## Revised Subdivision Plan

Changes are proposed to the subdivision as presented in Section 4.5.7 of the EIS.

Figure 2 Revised subdivision plan layout

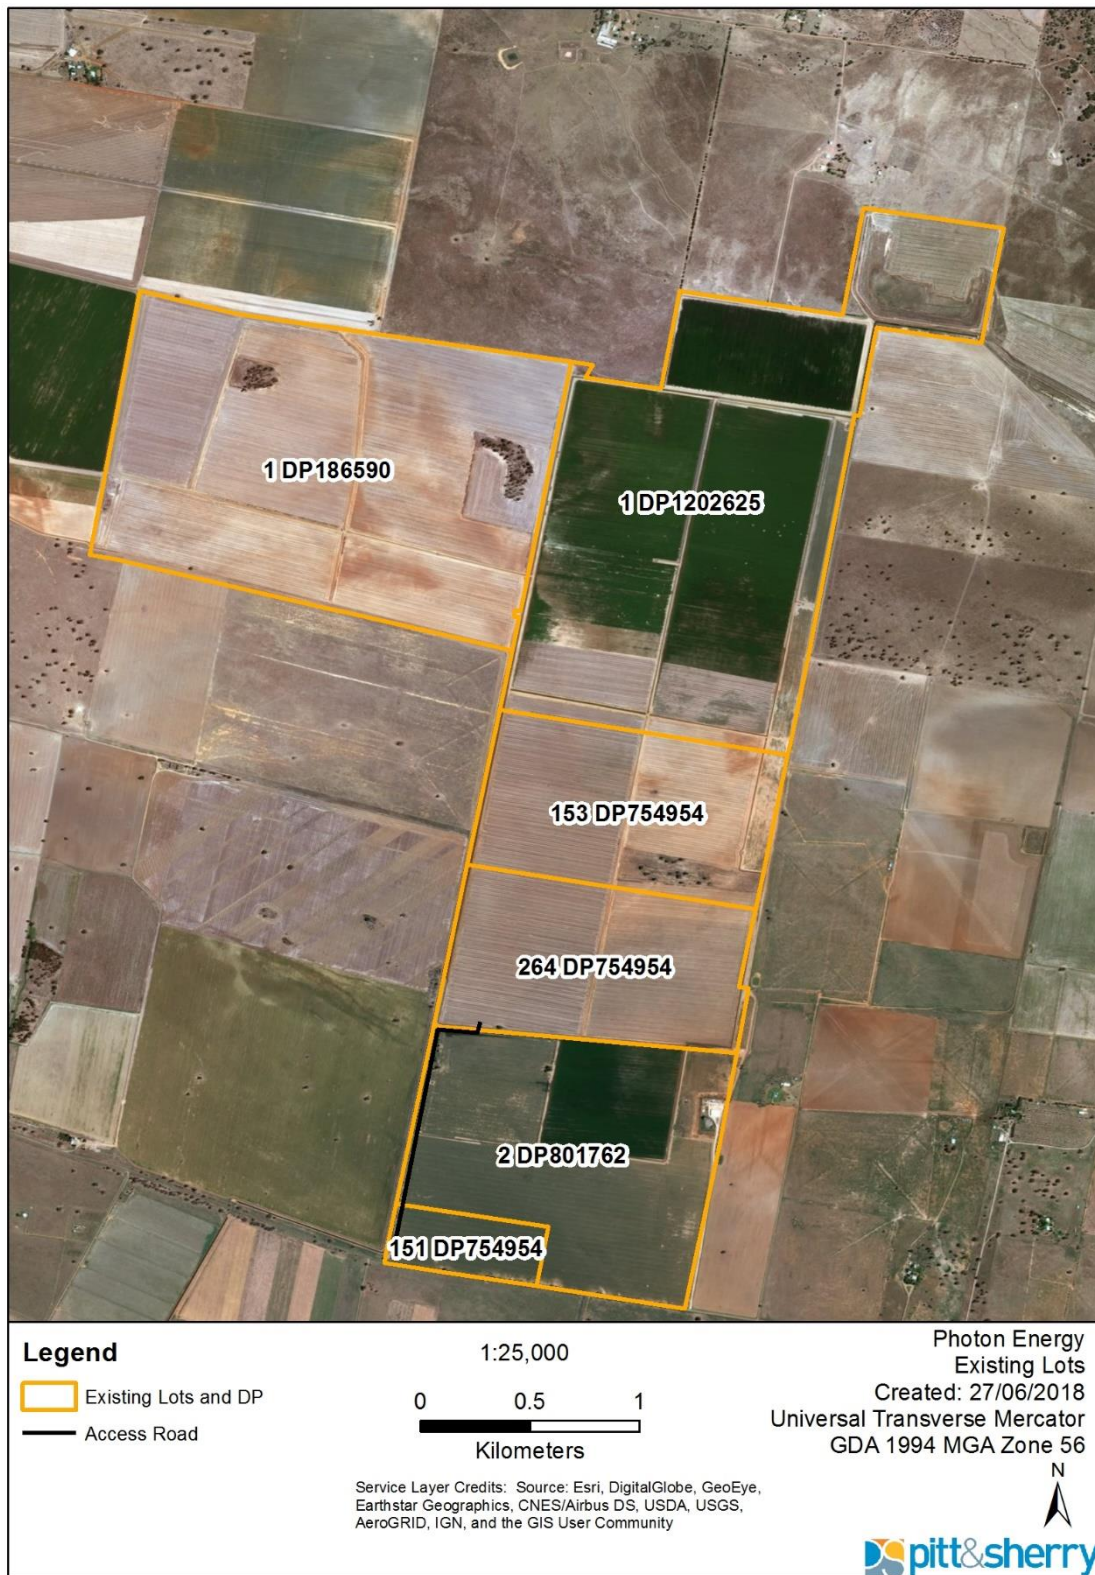
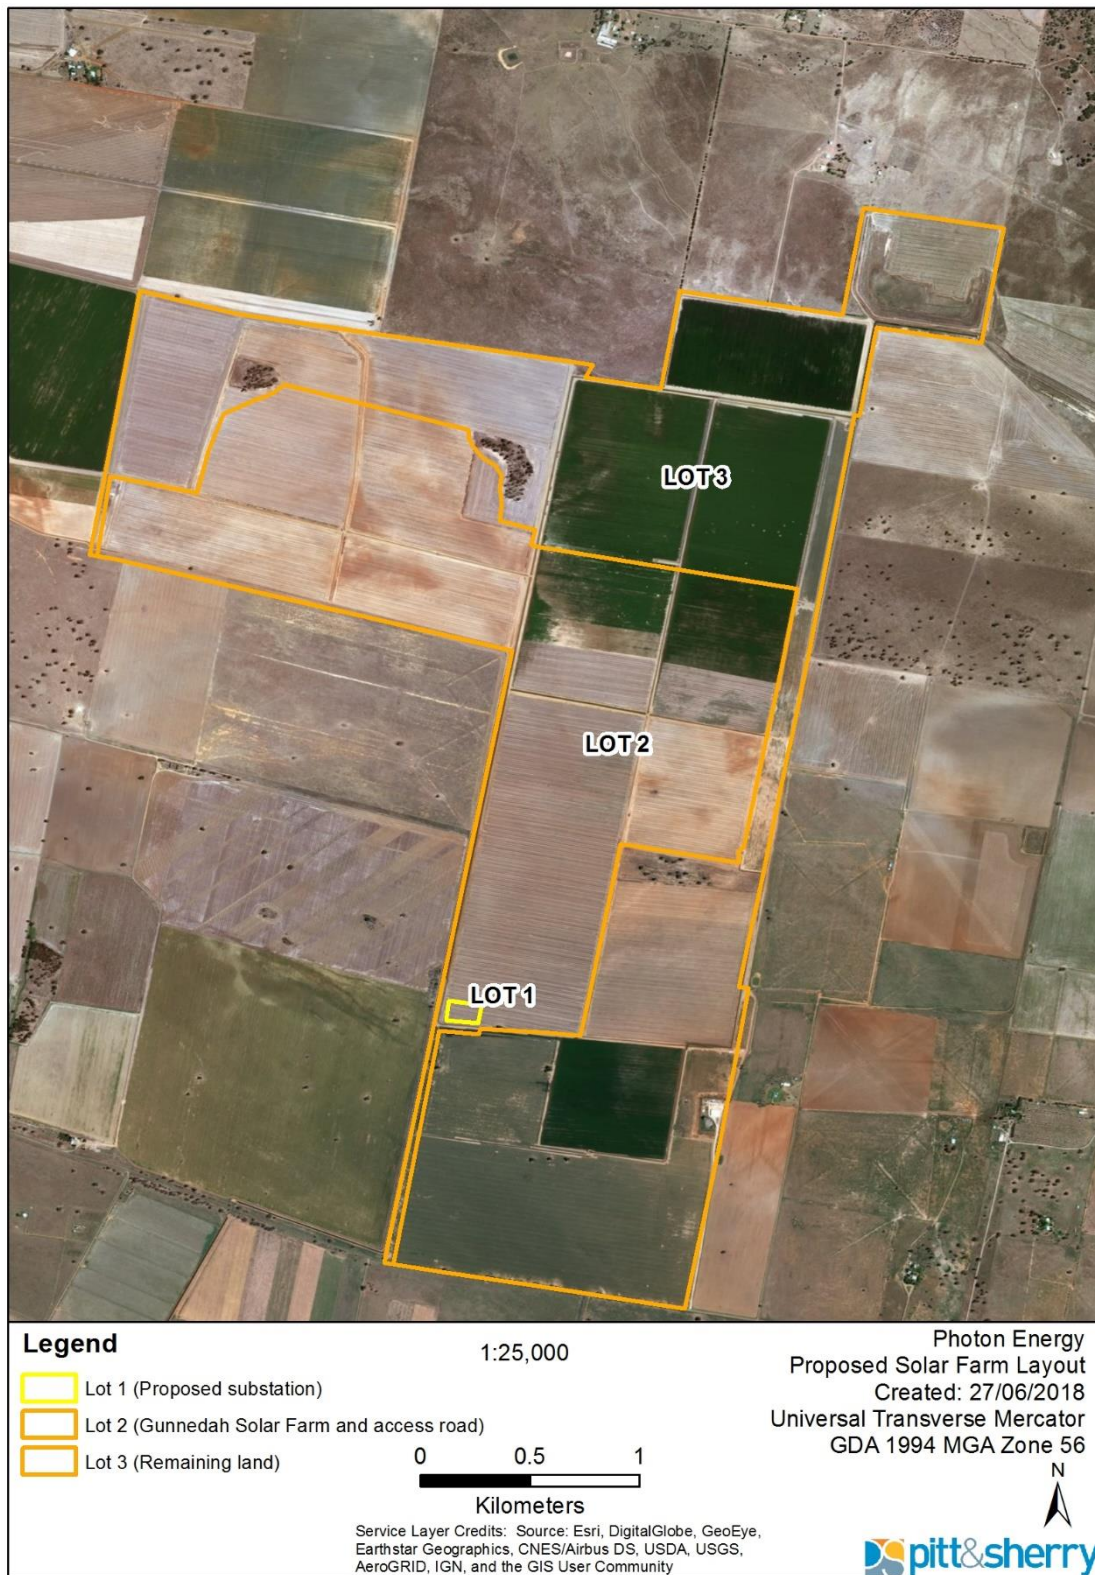
Existing subdivision of land is depicted in Figure 1. This revised subdivision plan identifies an additional subdivision of 4800m<sup>2</sup> on part of Lot 264 DP754954 containing the TransGrid substation. The need for this additional subdivision is to provide a separate lot to be owned by TransGrid to contain the substation.

Advice was sought from the Department of Planning by the consulting surveyor in relation to the exclusion of a lot for the TransGrid substation (27/06/2018). It was advised that this exclusion would be acceptable under SEPP Exempt and Complying Development Codes 2008, Clause 2.75 – Subdivision.

Under subclause (f) of the clause, land can be excised from a lot that is, or is intended to be, used for public purposes. Because the site currently comprises 6 lots, and even with a separate lot for the substation the final layout will be 3 lots, there are no new lots being created.

- Lot 1 – comprising the TransGrid substation which is estimated to occupy a 60m x 80m footprint and as such the lot would be 4800m<sup>2</sup>. This lot would comprise part of Lot 264 DP 754954.
- Lot 2 – comprising the Gunnedah Solar Farm and access road which is estimated to occupy 304ha. This lot would comprise parts of Lot 1 DP 1202625, Lot 153 DP 754954, Lot 264 DP 754954, Lot 2 DP 801762, Lot 151 DP 754954 and Lot 1 DP 186590.
- Lot 3 – comprising the remaining land associated with the Property to occupy 200ha and be reconfigured into a single lot in accordance with Gunnedah Shire Council request. This lot would comprise:
  - Approximately 93ha of Lot 1 DP 1202625
  - Approximately 165ha of Lot 153 DP 754954
  - Approximately 14ha of Lot 264 DP 754954
  - Approximately 40ha of Lot 2 DP 801762
  - Approximately 114ha of Lot 151 DP 754954
  - Approximately 151ha of Lot 1 DP 186590.

The proposed revised subdivision plan layout is provided in Figure 2.
